**Working instruction No. 2 for TN DG-G-09
LS8-t, LS10-st**

Installation of a fuel cock warning device in LS8-t, LS10-st

Material list: DG part No. 39000181 Material for TN DG-G-09 fuel cock warning LS8-t, LS10-st consisting of:

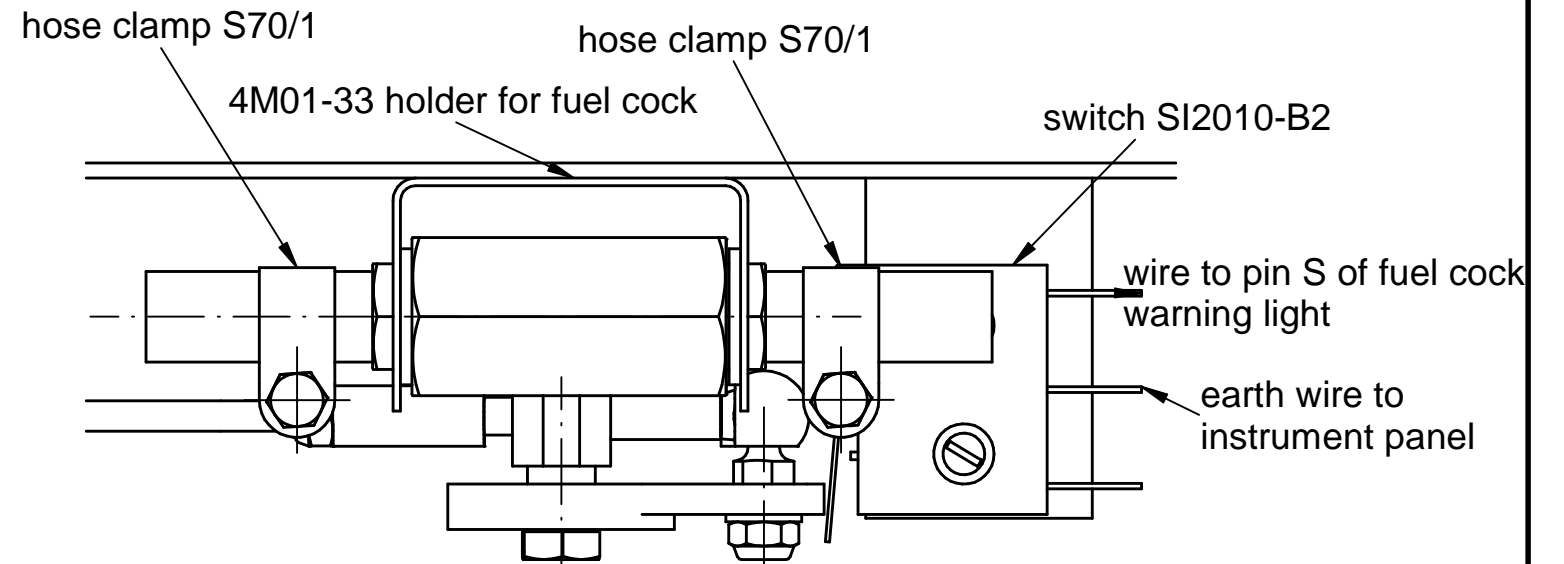
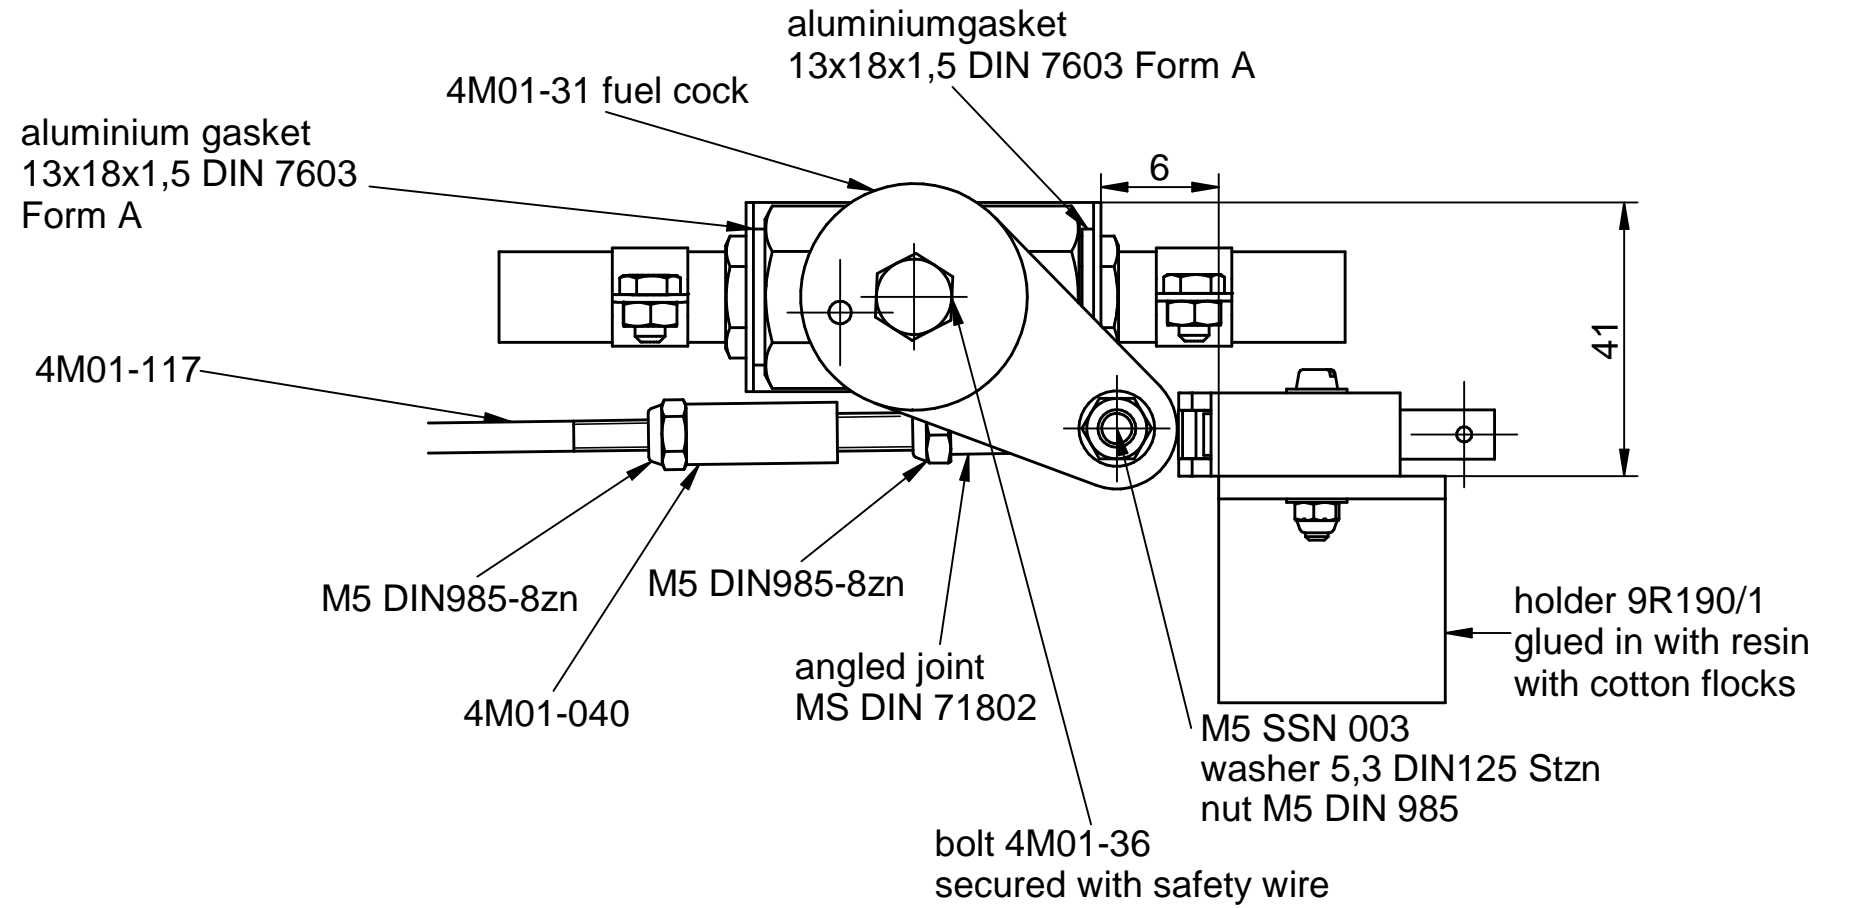
2. Assemble switch (SI2010-B2) to holder 9R190/1 according to drawing 9R190. Hold this unit to the fuselage wall so that the switch will be activated by the fully open lever of the fuel cock and mark the holder at the fuselage wall. Roughen the gluing surfaces at fuselage wall and holder. Glue the holder with resin/hardener mix thickened with cotton-flocks to the fuselage wall. Let cure

3. Plug wire 9R190/3 (from switch to DEI-NT) to the switch terminal (see drawing 9R190).
4. Plug wire 9R190/4 (from switch to earth connection) to the switch terminal (see drawing 9R190).
